Replace Charge Port Latch Actuator Carrier

Classification	Campaign Bulletin	Section/Group	44 - High Voltage System	Country/Region	United States
Year	2017	Model	Model 3	Version	All

Figure 4

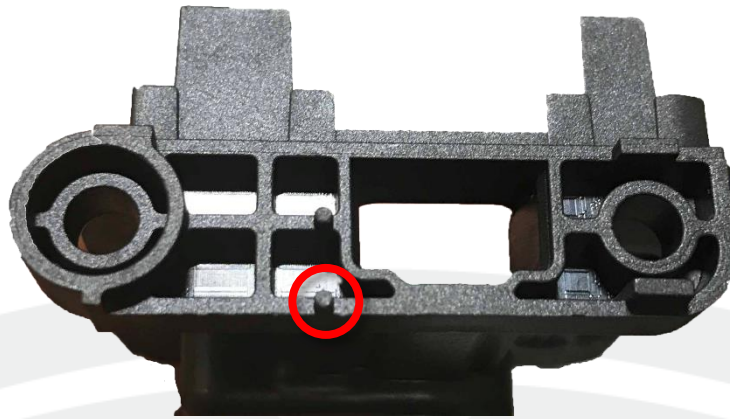
5. Use diagonal cutters or a razor to cut off the outer dowel pin from the new latch actuator carrier, and then file the area as needed (Figure 4).
